WALTER REED - BUILDING IJ HPRB FINAL FILING

Board of Zoning Adjustment
District of Columbia
CASE NO. 20134
EXHIBIT NO. 30C1

Project Narrative

ISSUE 1: WOOD LOOK CLADDING

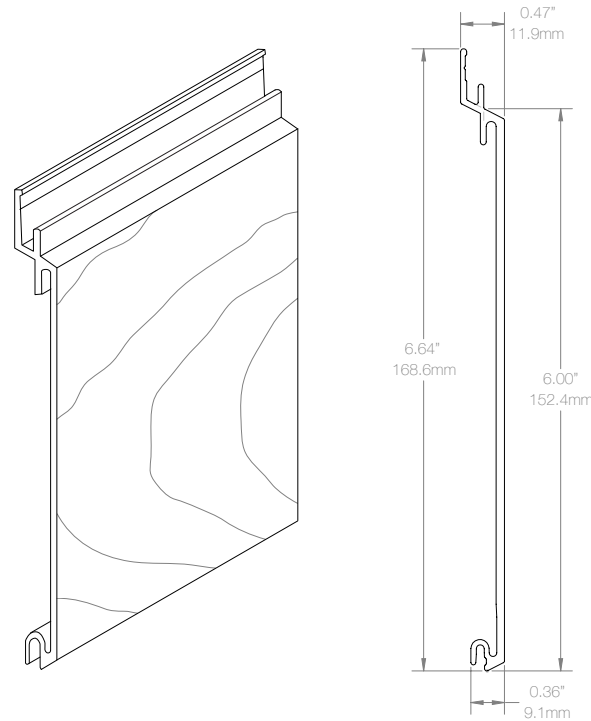
Nov 2, 2017 Board Comment

- Board requested that faux wood be changed to real wood materials

Sep 16, 2019 Update

- Real wood not permitted due to code limitations
- Wood-looking clad to be implemented as accent on levels 2-5
- Fiber Cement Lap Siding to be used on level 6, above the setback, and in alignment with the faux wood below

ISSUE 2: TOWNHOUSE REDESIGN

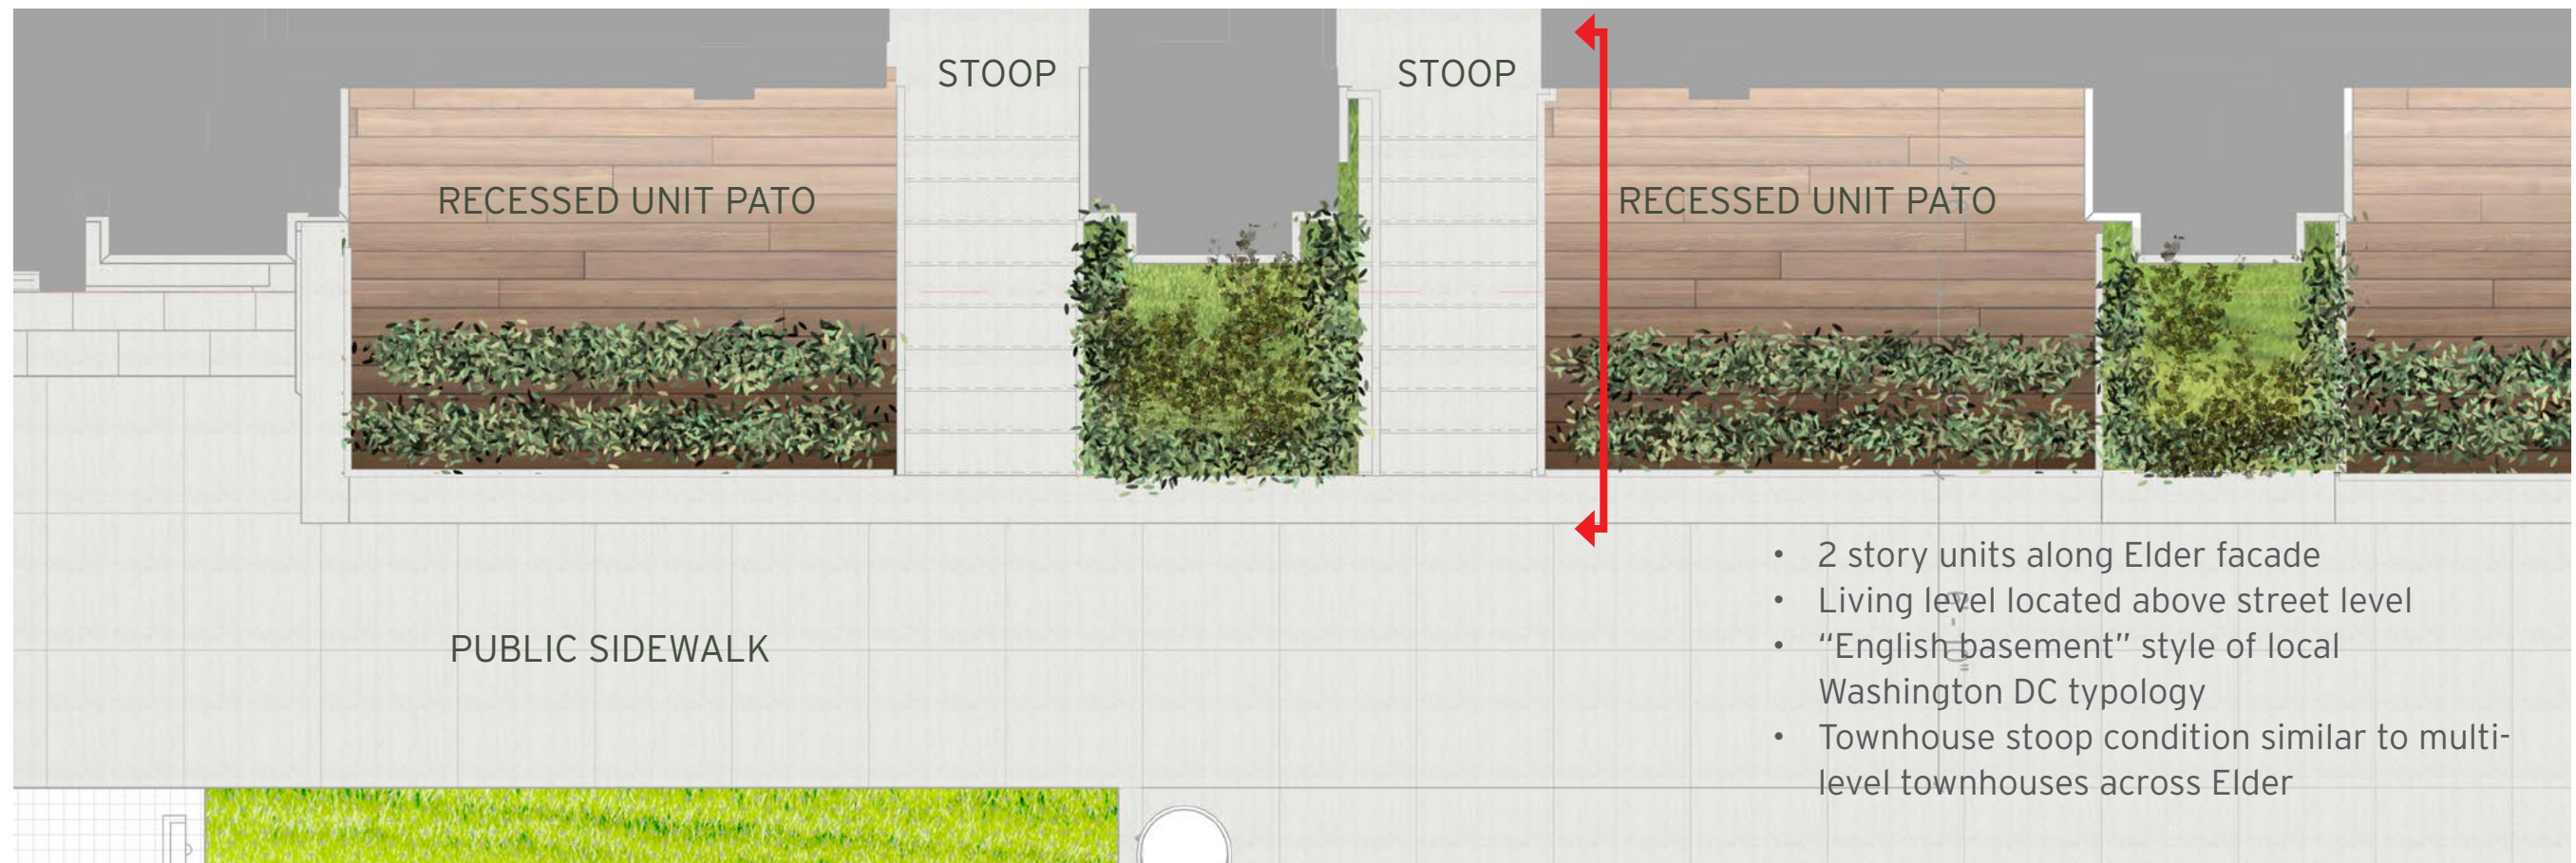
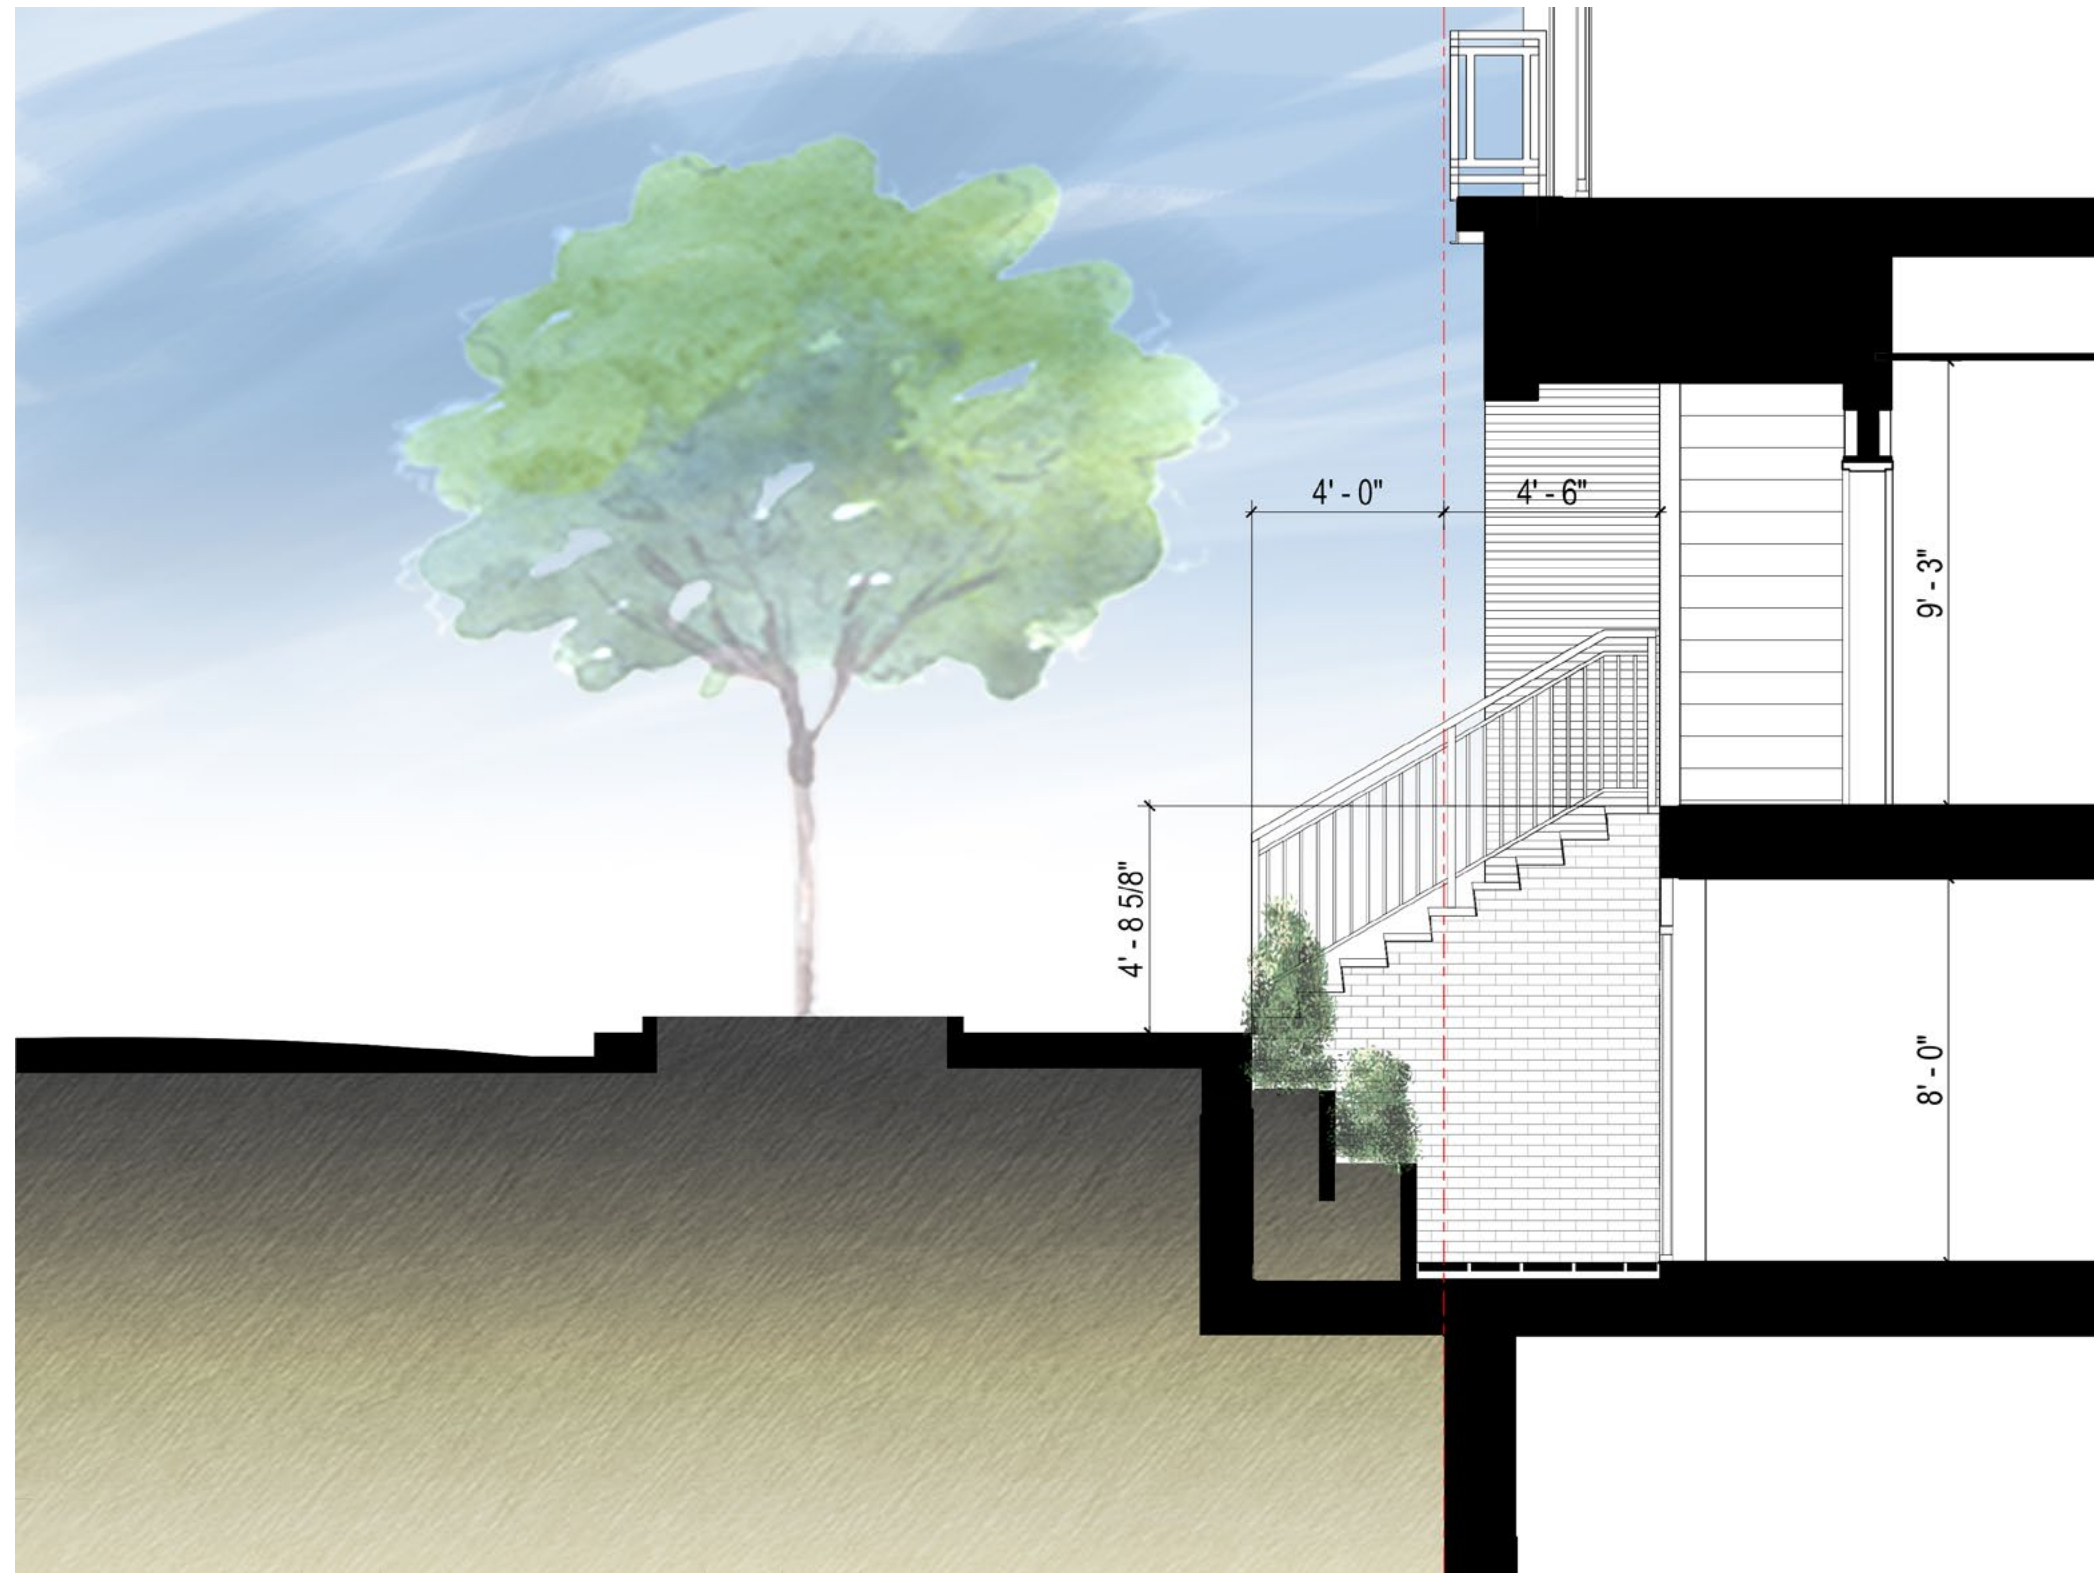
Summary of Changes to Townhouses

- 2-story units replace single story units
- Living level elevated above street level
- “English basement” style bedroom level with landscaped areaway

- Planting terraces added in residential areaway
- Softens grade change
- Increased privacy for residents
- Reflects more light into lowered space
